An
Coimisiún
Pleanála

FSC Report

ABP-322732-25

Construction of a Portal Framed
Storage Warehouse Building Unit 8,
incorporating ancillary two-storey
office space

Figure 28. Model for the shop shelf fire load entity: a) schematic presentation and b) some calculated characteristics.

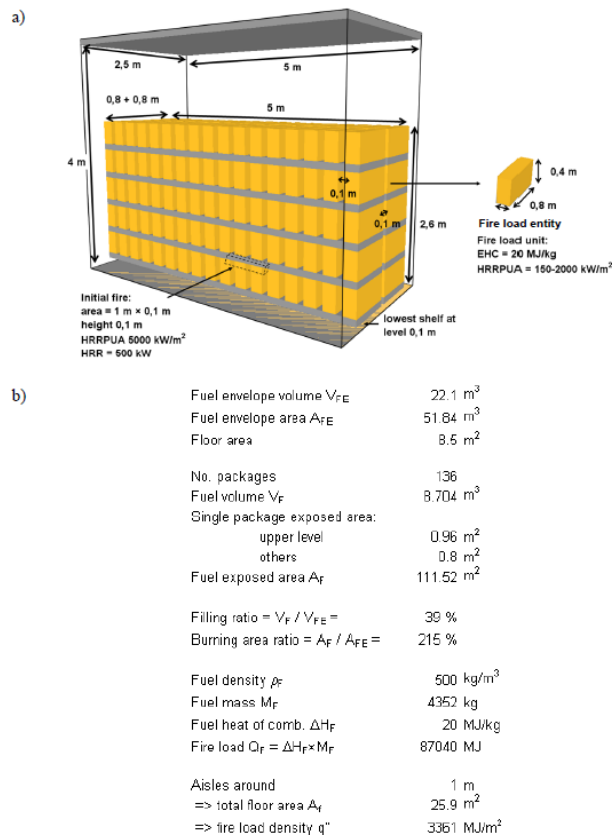
Unfortunately, the CFS Analysis does not demonstrate the use of Section 6 of the VTT guide. Instead the report reproduces the guidance from Section 5.4 and Figure 28 of VTT Report on “Shops and other commercial occupancies”. The example racking given in this section of VTT Report and reproduced in the CFD Analysis report (and in the figure below) has the following dimensional criteria:

While no measurements for the proposed racking system design were contained in the documents reviewed an examination of the drawings received suggests that the proposed racking system in these warehouses has the following dimensional criteria:

- Racking Height = 12.5m
- Racking Length = 55m
- Racking Width = two 1.2m racks back to back giving a total width of 2.4m
- Ceiling Height = 13.8m
- Separation Distance: 1.8m (across aisles to other racks),

To adopt the guidance in Section 5.4 and Figure 28 of VTT for racking in use in “retail shop shelves” to model high-bay racking of the above dimensions in an unsprinklered storage warehouse is, in my opinion, fundamentally flawed.

The CFD Analysis report does mention Section 6 of the VTT Report but provides no evidence that the racking systems proposed has been modelled as fuel packages in FDS to determine the appropriate HRRPUA. Instead the CFD Analysis Report simply states that a HRRPUA of 1030kW/m² has been determined as being appropriate in this case.
